GRADING & DRAINAGE PLAN

GRADING AND DRAINAGE PLAN
MORGAN BUILDING SYSTEMS
10026 CENTRAL AVE. SE

TRAFFIC CIRCULATION LAYOUT

MORGAN BUILDING SYSTEM
10024 CENTRAL AVE. SE

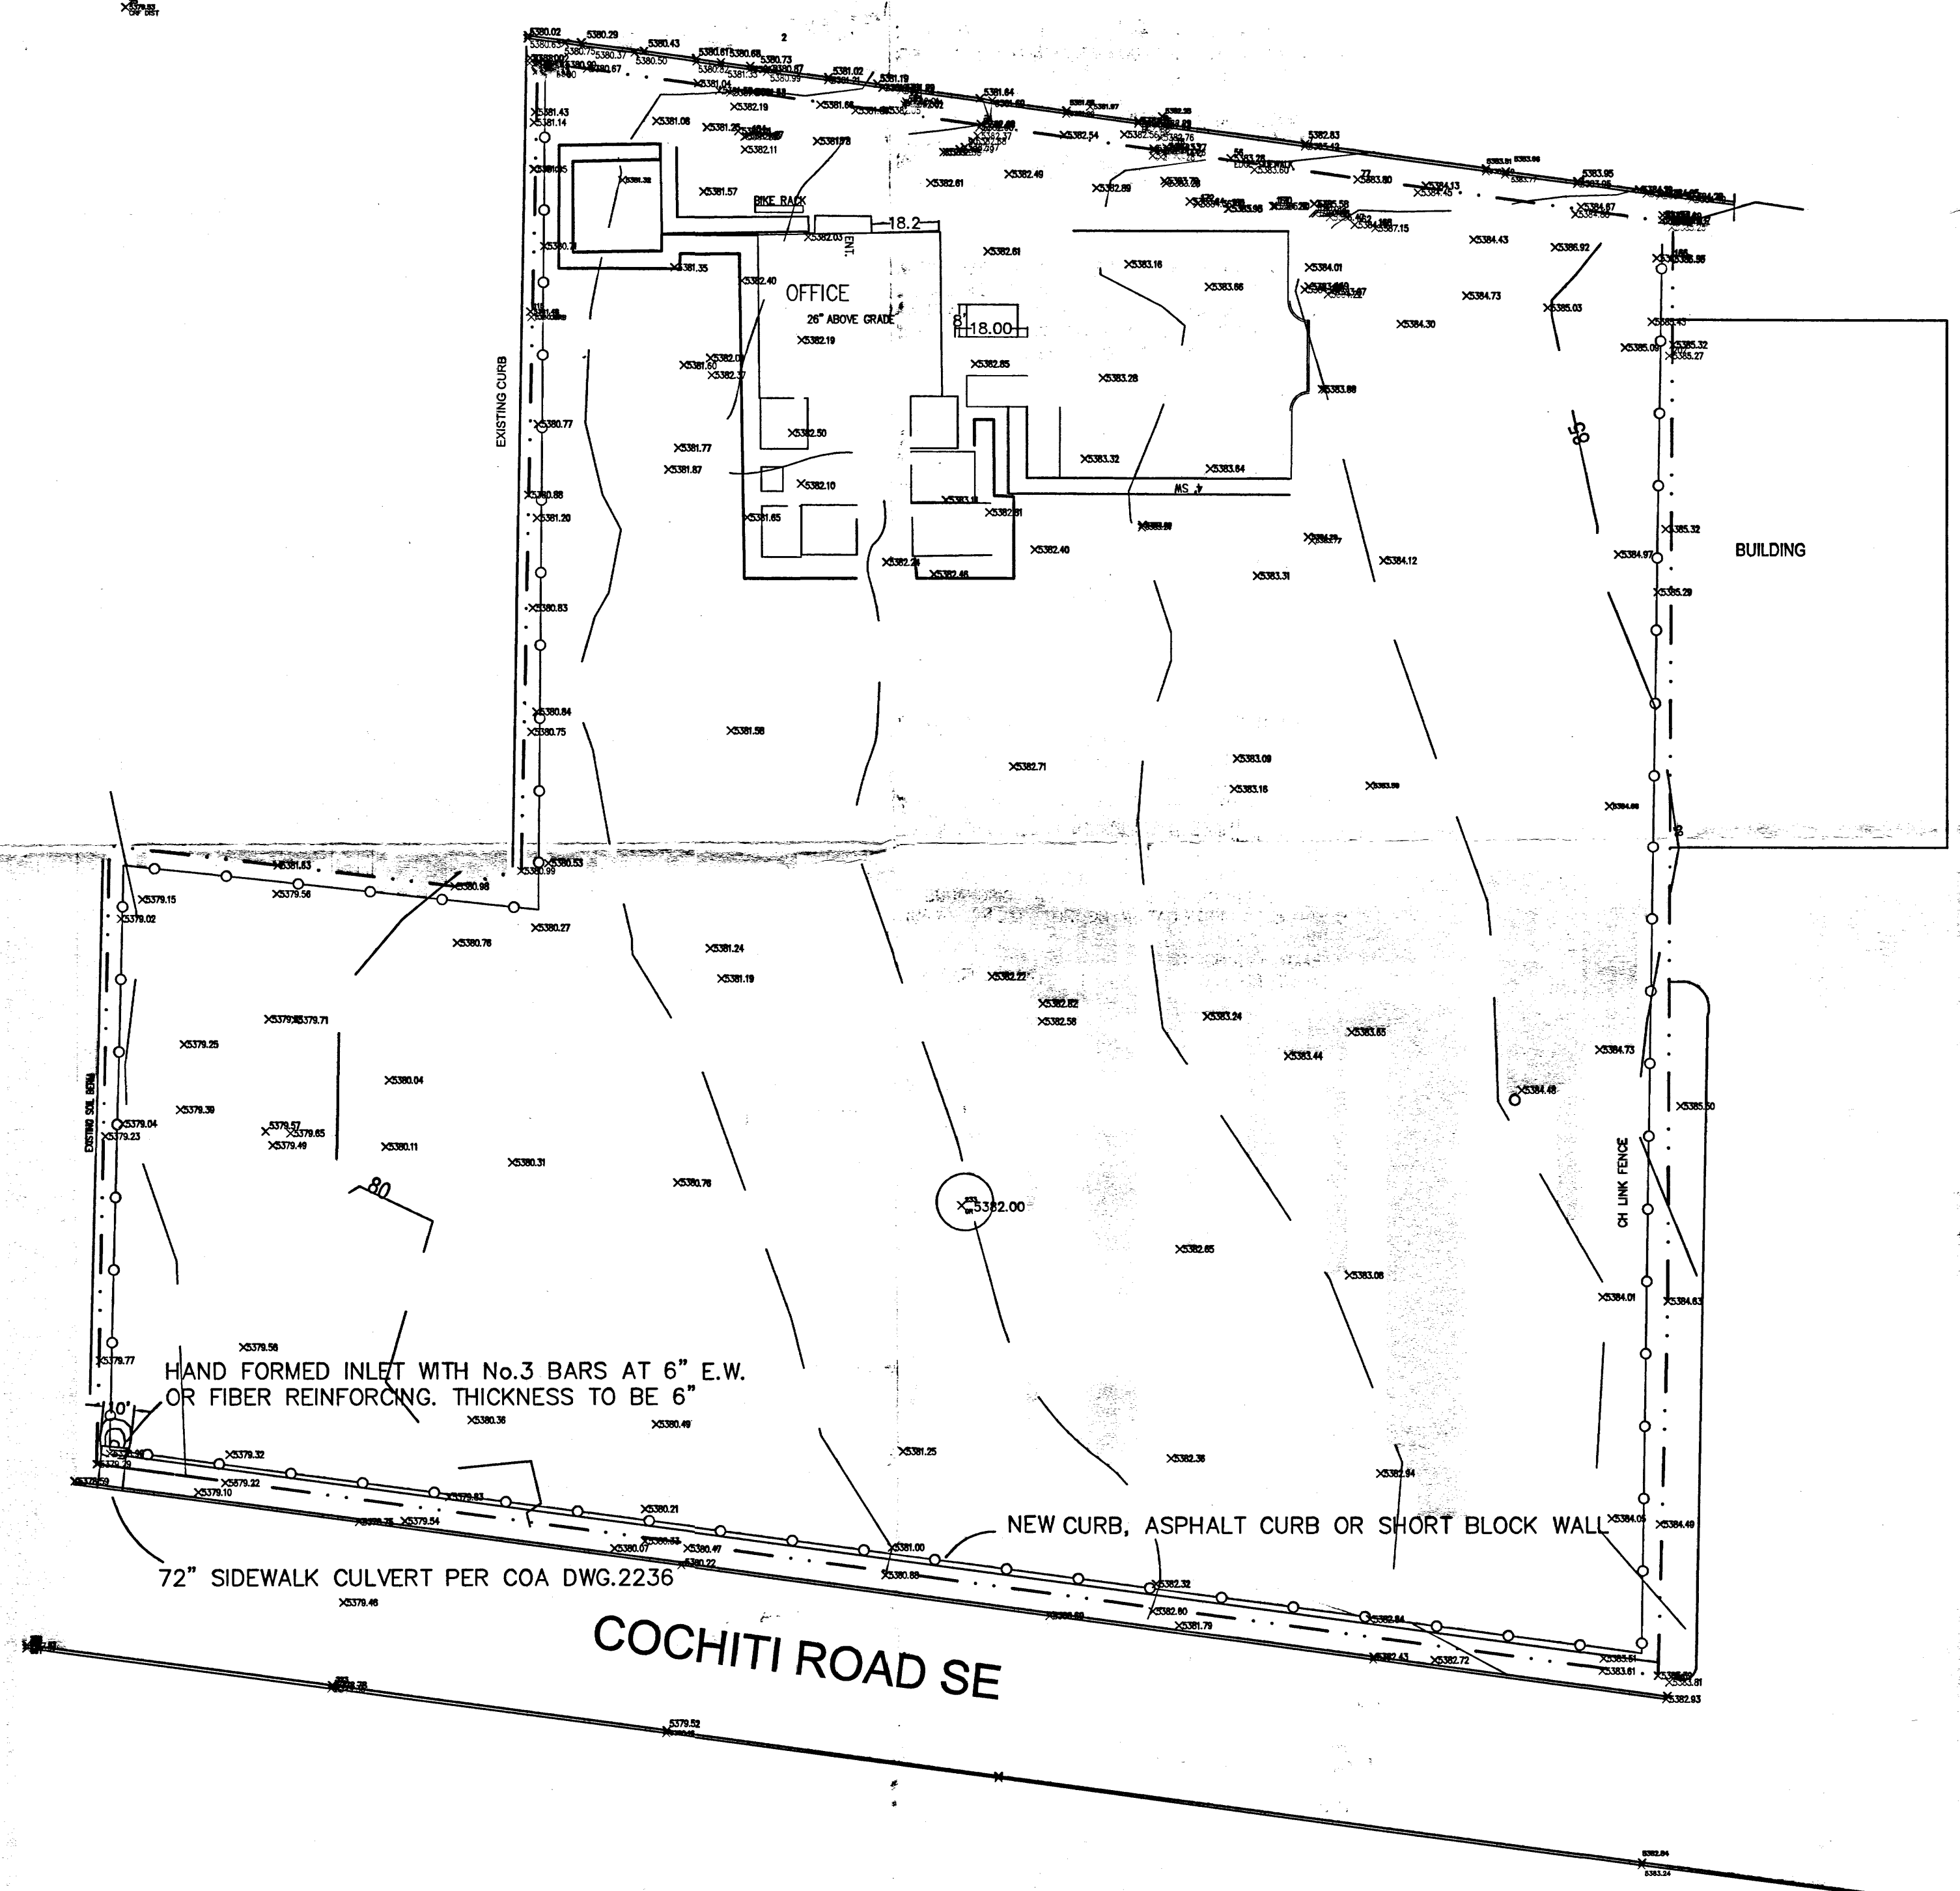
I, Wallace L. Bingham, certify that this site is in substantial compliance with G&D Plan date stamped 11.23.08 with the following exceptions:
The following has not been completed:
Water stop (curb or low wall) on the south property line
72" Sidewalk Culvert in the Southwest corner of the site
Construct inlet to the sidewalk culvert as indicated on the plan
Relocate Entrance to the east and add curb returns
New 10 foot sidewalk at the North property line
Water Stop/Diversion beginning at the Southwest corner and continuing inside the fence, north for a distance of 15 feet
Construct sidewalks at all locations shown on the plan

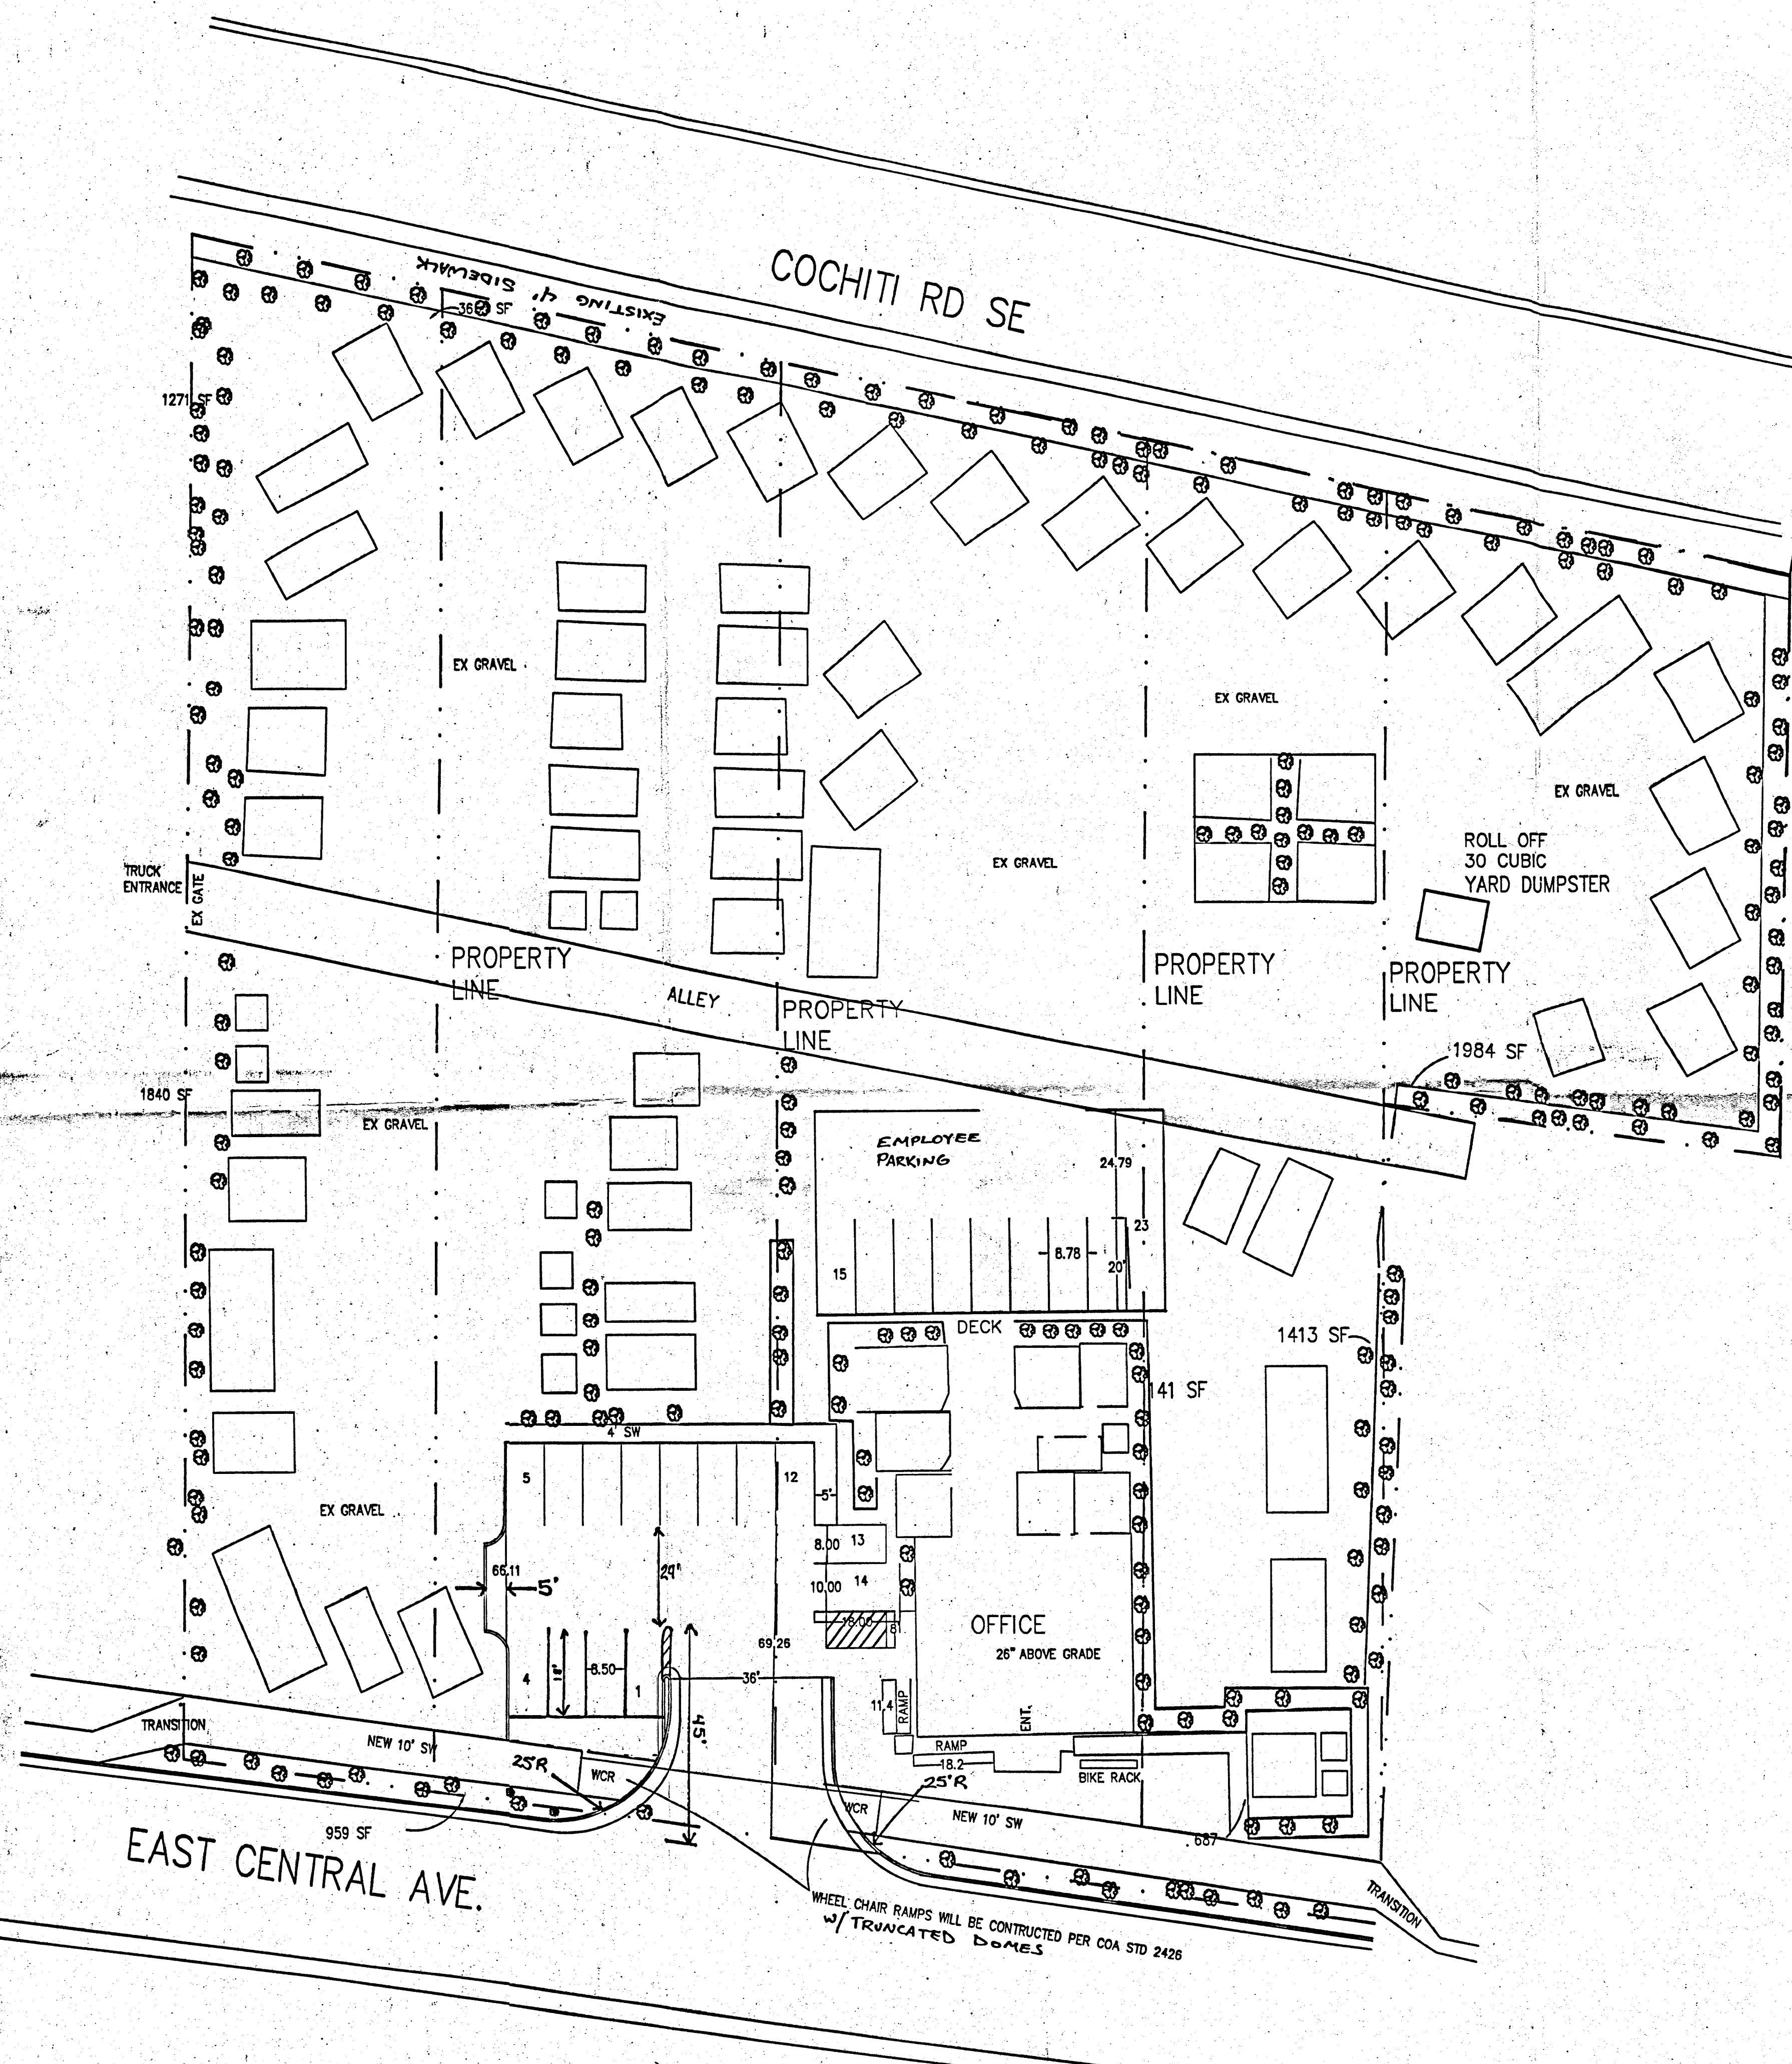
I, Wallace L. Bingham, Certify that this certificate is in substantial compliance with the plan stamped and dated on 12-11-08 with the following exceptions:

- Construct Side walks where indicated on the T.C.L. Plan
- Install Bike Rack
- Install parking bumpers
- Complete Landscaping where indicated
- Construct New entrance to the East of existing
- Renew parking lot Paint with traffic paint.
